FIELD REPORT

Field Report No. 2

Date: May 6, 2016
Project: Madison County Courthouse
Preliminary Leak Investigation at Cupola
Canton, Mississippi
BSA No. 1208.2

Purpose of Site Visit: Further Investigation of Cupola to identify locations of water intrusion.

1 - WINDOW SILLS

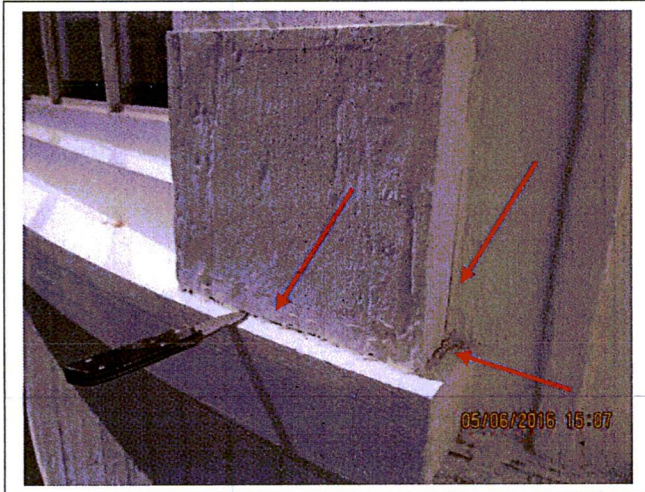
1. Sealant: The sealant at the base of the vertical wood trim at the both sides of the South Facing Window has failed and separated, leaving open paths for water to the interior especially during significant heavy and blowing rain conditions.
2. Due to water leaking at the sill for an extended period of time, the interior wood sill at the South Window has severely rotted (completely through) and has become loose from other wood supporting vertical members.
3. The South Window Sill also has a slight "crown" at the center diverting water to the base of the trim at either side.

Recommendations: In the short term, all sealant at base of the vertical wood trim (Both sides of Sill) at the South Window should be removed, joints cleaned out and new sealant installed to minimize water intrusion into the Courtroom space. Due to limited lifespan/effectiveness of sealants, the removal and replacement of all existing exterior sealant at windows around the Cupola and replacement/repair of damaged/rotted wood window support sills and surrounding wood members should be included in the work scope of a Cupola Restoration/Repair Project.

2 - VERTICAL WOOD SIDING JOINTS

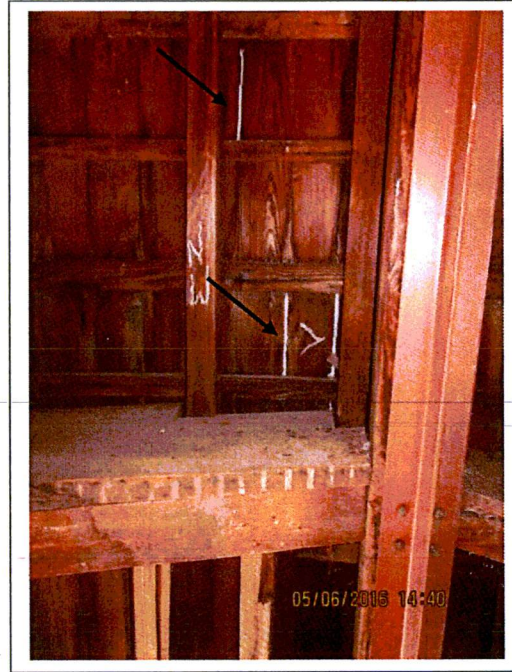
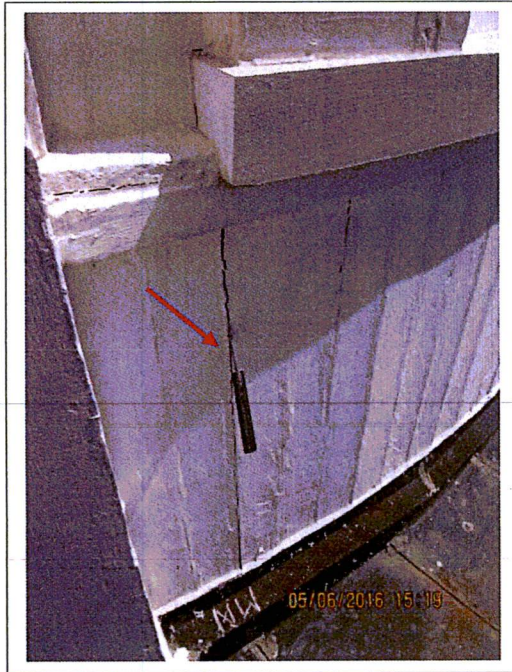
1. Several of the vertical tongue and groove siding boards have separated, leaving open joints. Daylight could be seen from the interior of the cupola in some locations and there are water stains on the backsides of most boards. Some attempts in the past to fill the joints with sealant was observed.

Recommendations: In the short term, all vertical siding should be examined, open joints identified and sealed at the exterior face. As part of a Restoration/Repair Project, all vertical tongue and groove siding should be removed and deteriorated boards discarded. Any existing boards in good condition should be salvaged, restored to a well-maintained condition and reinstalled. New exterior grade tongue and groove wood siding boards, matching the existing exactly, should be used for replacement where required. A continuous sealant bead of sealant should be installed in the groove of each board. Damaged/deteriorated interior support framing boards should also be carefully examined, identified and replaced as required. All perimeter joints should then be appropriately sealed. The application of primer and exterior grade elastomeric paint/coating will protect the wood and allow for some movement capabilities. Options for the replacement of the wood siding may also be considered to either limit or eliminate the joints all together. Any alternative material considered will require careful attention to detail in order to retain the look and character of the cupola as well as the approval by MDAH.

3 - COPPER CLAD CUPOLA BASE AND FLASHINGS

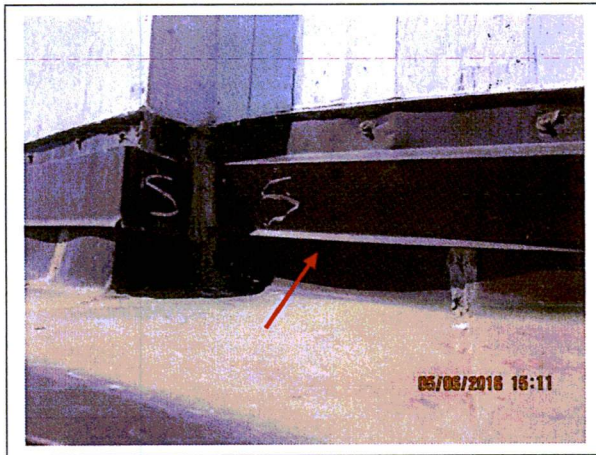
1. The sealant at the top of the Copper Counter Flashing to the Vertical Wood Siding is deteriorated and failed in some locations allowing for a point of water intrusion behind the flashing.

2. The vertical counter flashing leg in some locations is not pulled tight to the back vertical leg of the ledge cover/flashing leaving a large gap (large enough to get fingers up behind). The back leg of the horizontal ledge flashing is only 2-3" high. With a wind driven rain, water can be blown in up behind the counter flashing, over the vertical leg of the ledger flashing and into the building.

3. The copper ledger flashing is in fair to poor condition with very limited to no slope to shed water as observed by the water stains and residue. The soldered joints in the copper ledge flashing are in poor condition and with the standing/ponding water, failed joints will allow water into the building.

4. The wood decking and support framing members at several locations around the cupola, at the underside of the stepped ledge, are water stained and severely rotted/deteriorated or in very poor condition due to leaking over time.

Recommendations: Based on our observations of both the interior conditions of the copper ledge, all existing copper flashings and horizontal decking should be removed. Even though most areas and conditions can be observed from the interior allowing for the generation of a good work scope for the repairs and restoration, a more thorough investigation needs to be conducted of the framing members and surrounding conditions once the copper and decking is removed. All rotted and deteriorated wood framing must be repaired/replace/reinforced as required. New wood decking, tapered to slope and shed water, is needed to eliminate standing water. The installation of a self-adhering waterproof membrane flashing material over the new wood decking should also be installed. Properly installed metal ledge covers and counter flashings, seamed, properly lapped, anchored and sealed will ensure watertight conditions. The counter flashing over the vertical leg of the ledge cover flashing needs to be installed in a manner as to avoid a sealant dependent joint at the top and all vertical legs of flashings must extend high enough to prevent migration of wind driven rains up over the top.

We also recommend a review of all copper by a copper restoration/repair craftsman to help determine if all or some copper components can be salvaged, restored, modified and reinstalled in a manner to provide watertight conditions.

Although copper is the preferred metal for the replacement of any or all components, a galvanized prefinished bronze colored metal may be a less expensive option. Careful detailing and installation to ensure watertight joints along with approval from Mississippi Department of Archives and History (MDAH) will be required in going with a pre-finished galvanized metal.
